VITRIFICATION OPTIONS:

Further discussion of my previous oral statement

February 1979

Raymond C. Vaughan (Coalition on West Valley Nuclear Wastes)

Figure 1

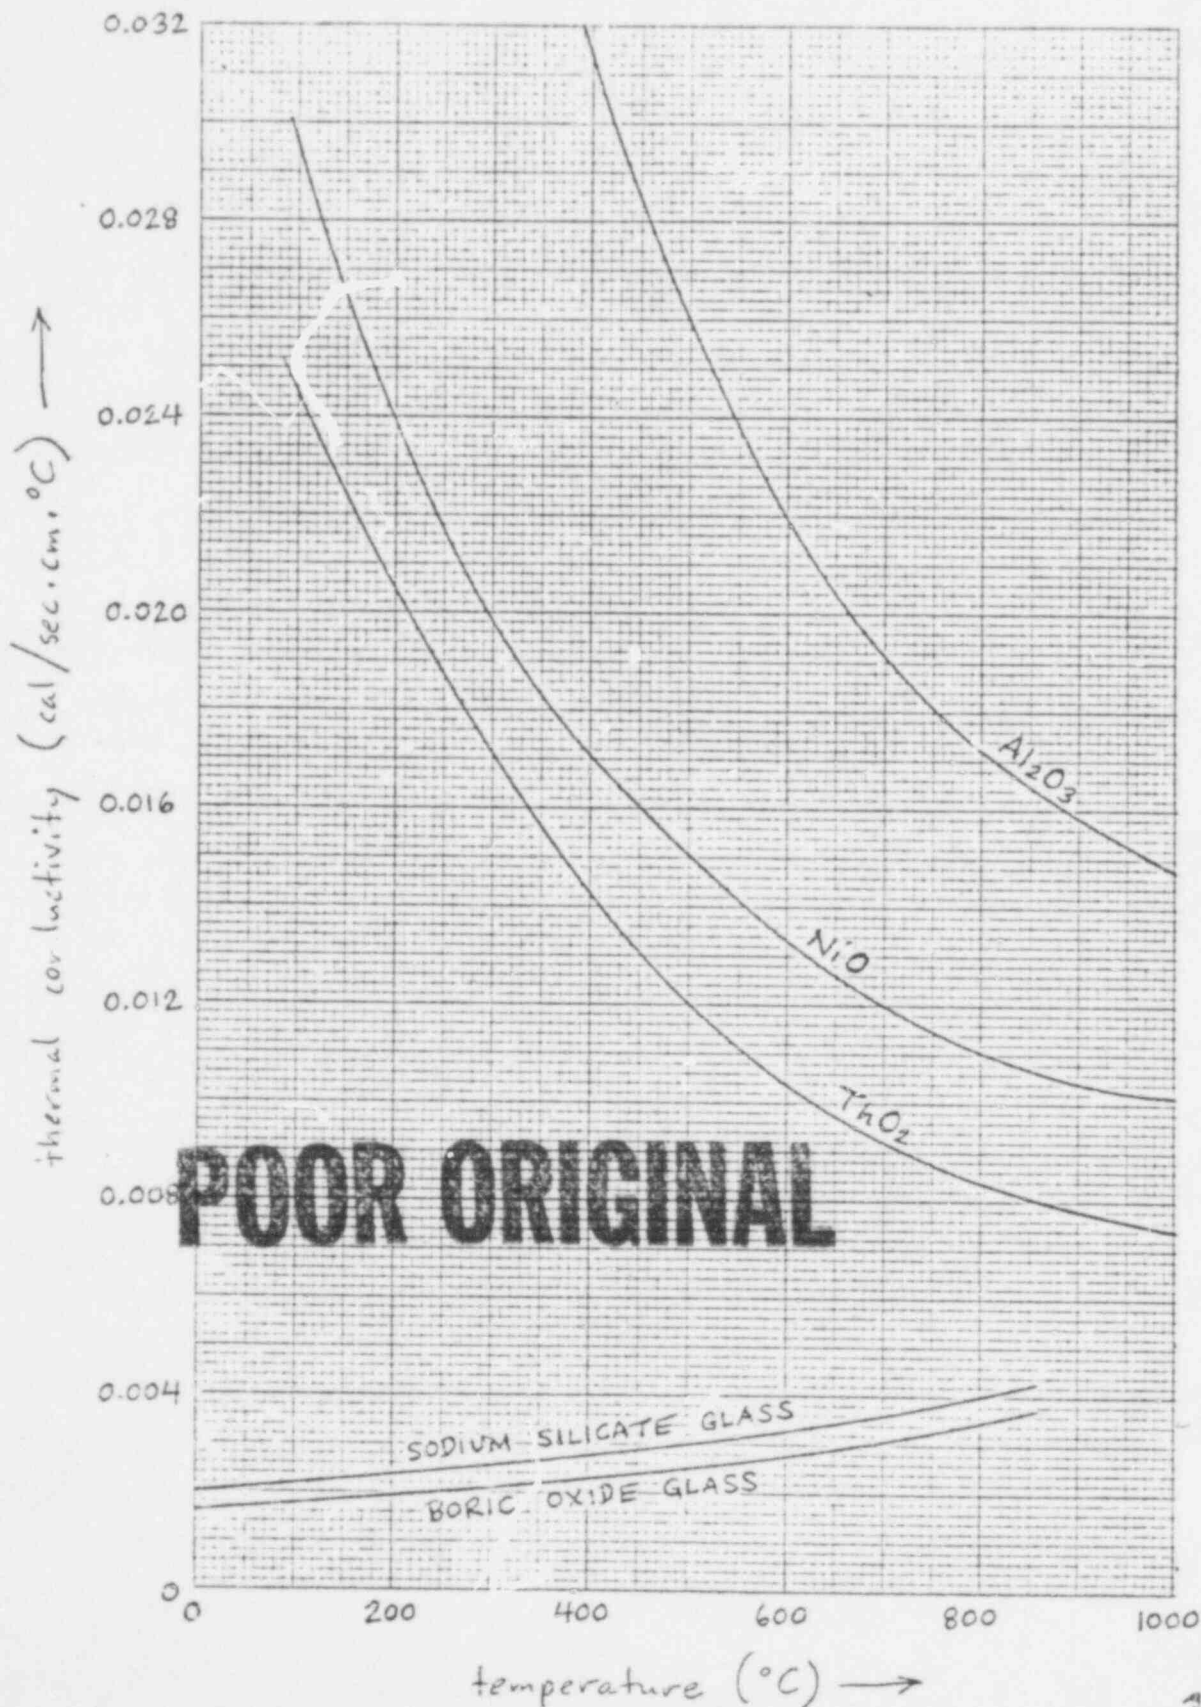
Thermal conductivities of some of the calcined powders and of the proposed glass matrix materials are shown in Figure 1. Note that these will determine the overall conductivity of the powder-in-glass composite in the canisters. For the sake of illustration, I will assume  $0.002 \text{ cal}/(\text{sec-cm-}^\circ\text{C})$  for the overall thermal conductivity; this is a rather conservative estimate.

Figure 2

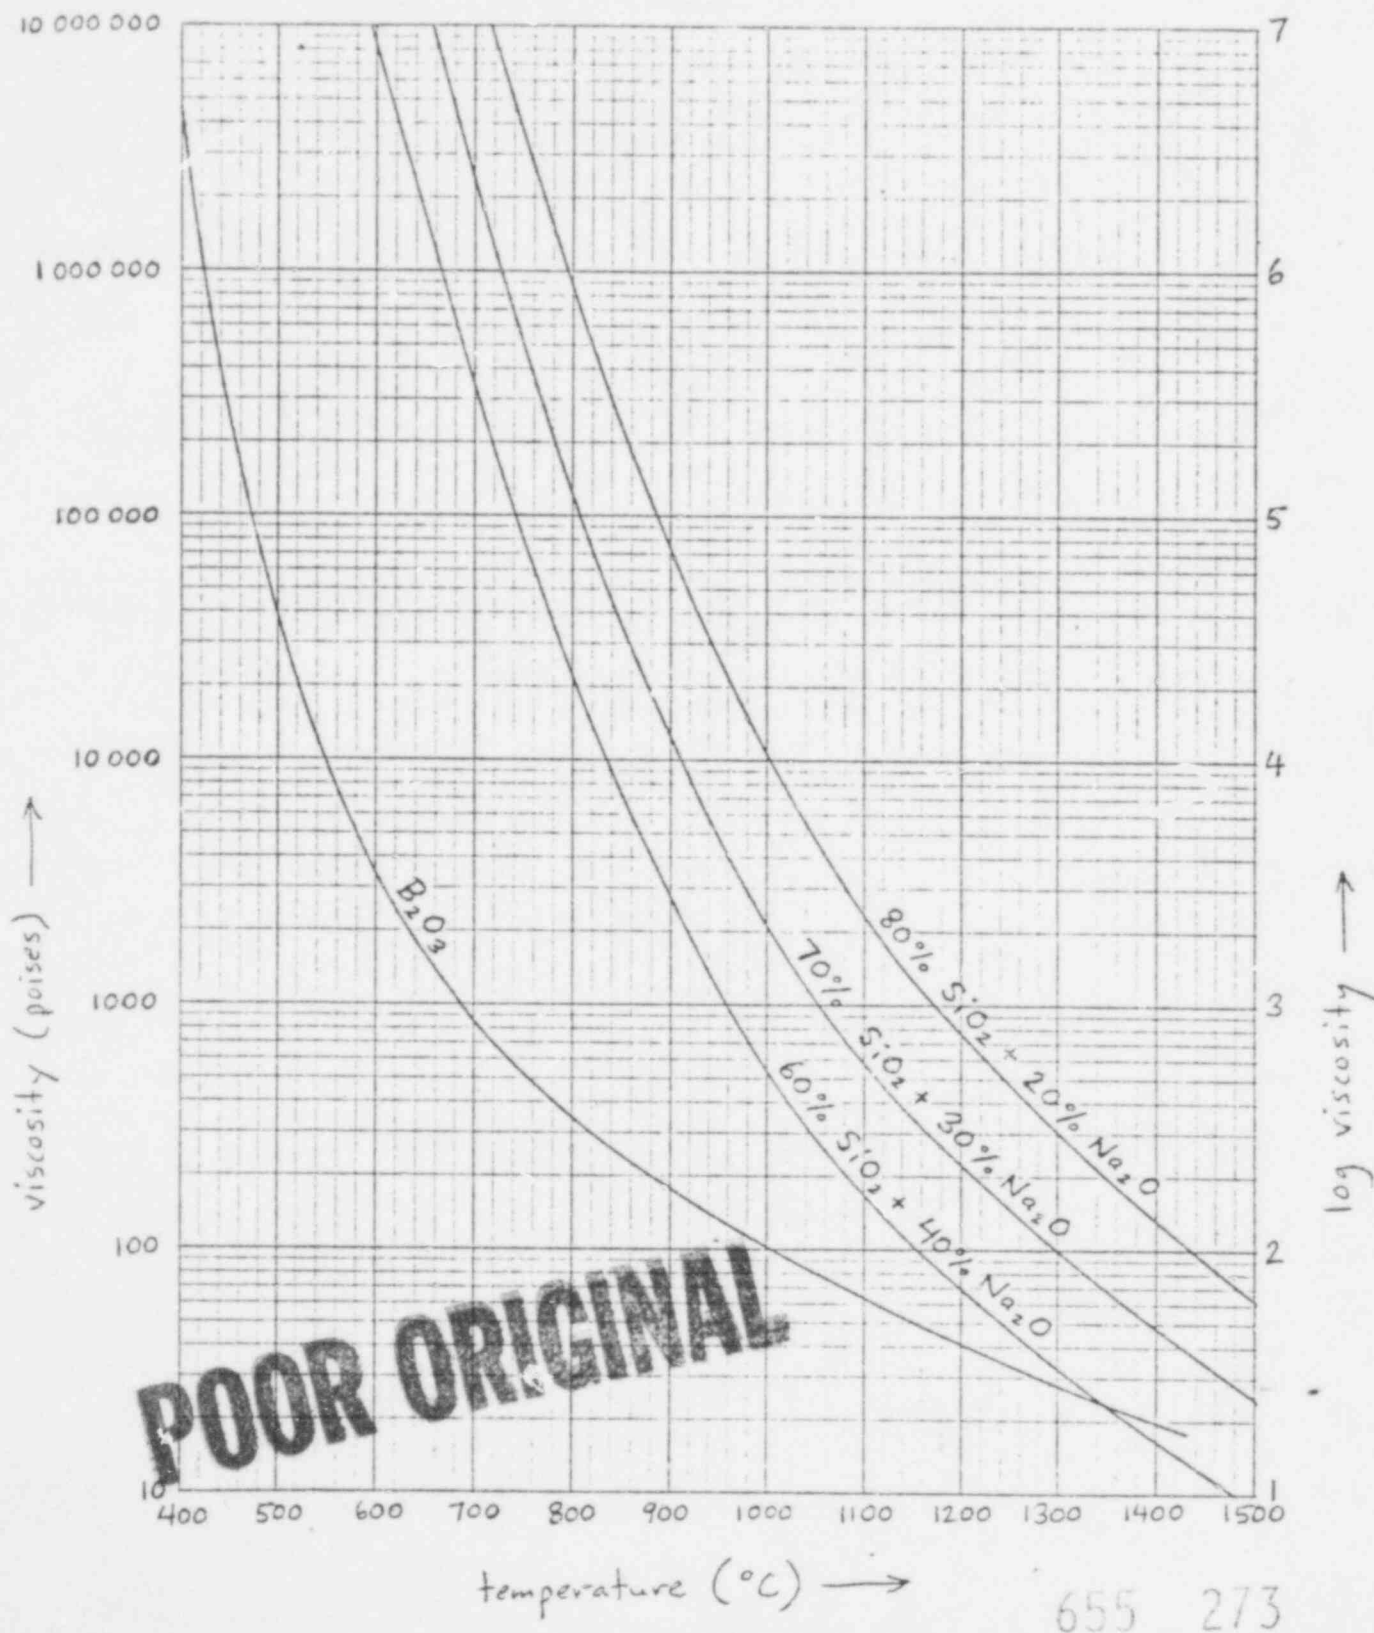
I propose mixing the calcined waste powder into the molten glass, at as low a temperature as possible, which would probably be about  $600^{\circ}C$ . The viscosity-temperature curve for boric oxide glass is shown in Figure 2. The proposed mixing or kneading process could be tested with a non-radioactive calcined powder to determine its feasibility. Such a mixing process will not be easy, but with proper design may be feasible. It would be roughly comparable to the problem of mixing a powdered material (such as talcum powder) into a fluid whose viscosity is like cold honey, but whose temperature is verging on visible red heat, without mixing in too many air bubbles. Higher temperatures would make mixing easier by reducing the viscosity of the boric oxide, but would increase the required operating temperature of the mixing equipment and might also increase the volatilization of some of the radioactive substances. For comparison, calcination temperatures are in the neighborhood of  $500^{\circ}C$ , while vitrification temperatures are in the neighborhood of  $1100^{\circ}C$  (41).

Anhydrous sodium silicate glasses typically consist of 50% to 90%  $\text{SiO}_2$ , with the remainder being  $\text{Na}_2\text{O}$ . Viscosity-temperature curves for representative sodium silicate glasses are shown in Figure 2. The composition of the glass is frequently expressed as the ratio of  $\text{SiO}_2$  to  $\text{Na}_2\text{O}$  by weight (48), so that a 2.0:1 ratio anhydrous glass consists of 66.7%  $\text{SiO}_2$  and 33.3%  $\text{Na}_2\text{O}$ .
